1992 - 1993 Corvette: Recall: Power Steering Gear Inlet Hose

Subject: PRODUCT SAFETY CAMPAIGN 93CO2 - POWER STEERING GEAR INLET HOSE

Model and Year: 1992-93 CHEVROLET LT1 CORVETTE

Bulletin Number: 93C02

Figures on page 4 may assist in performing this repair procedure.

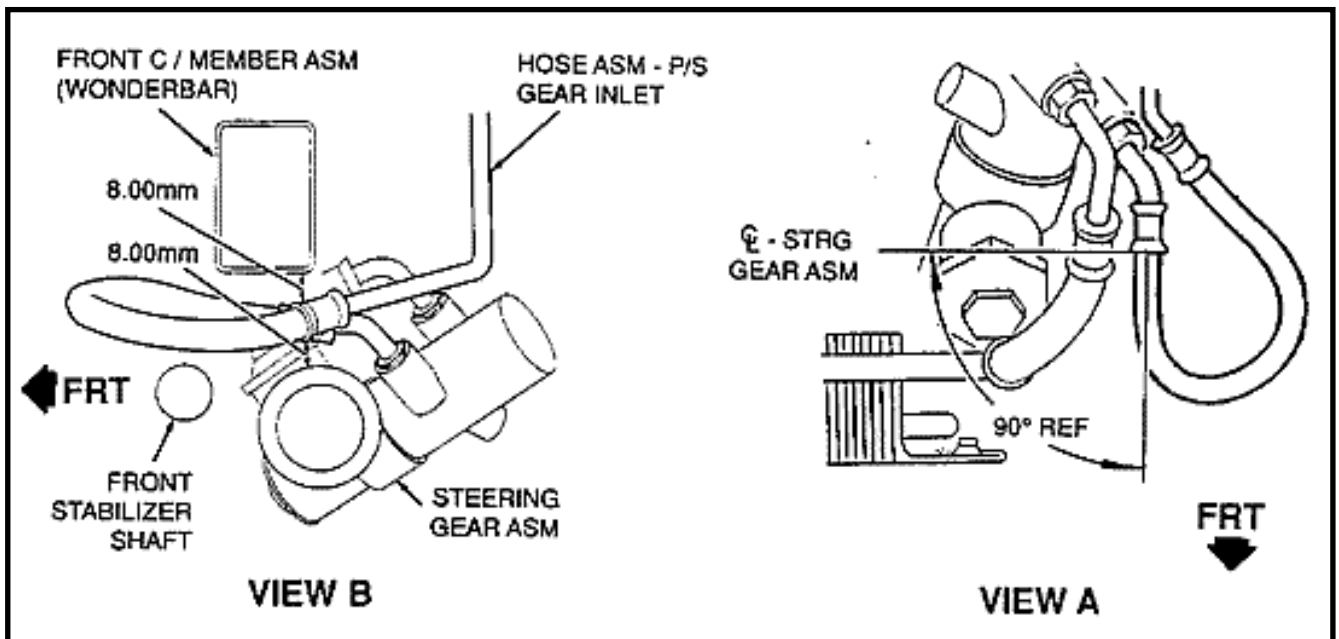
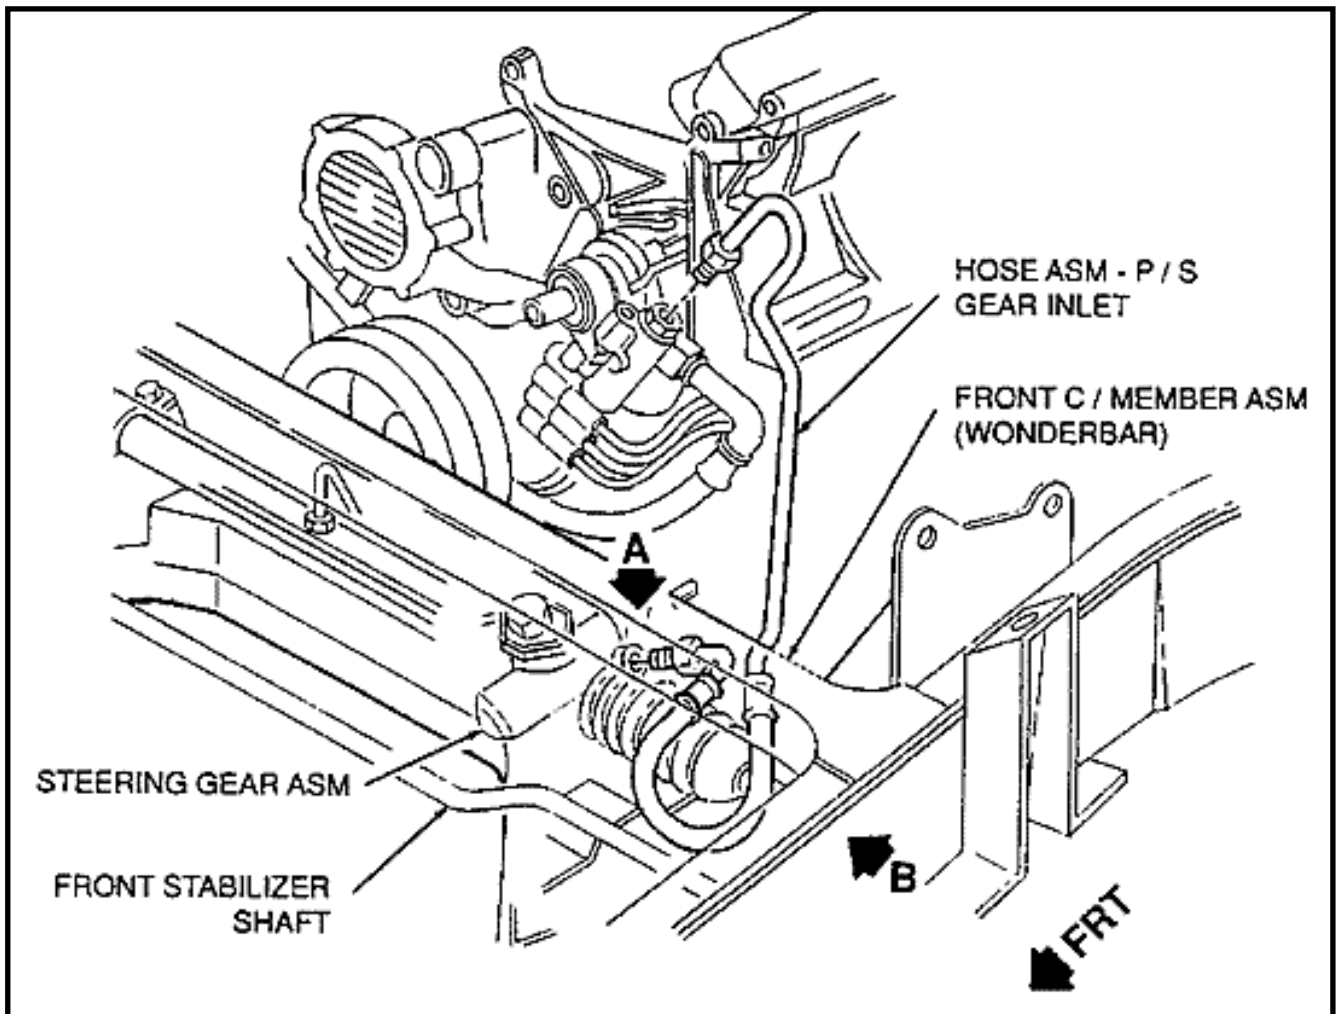
Notice: Be certain to leave adequate clearance between front cross-member and hose/pipe assembly. View B on page 4 illustrates proper clearance.

1. Install new power steering gear inlet hose following procedures on page 3B-6 of either

the 1992 Corvette Service Manual (ST-364-92-1) or the 1993 Corvette Service Manual (ST-364-93PSID).
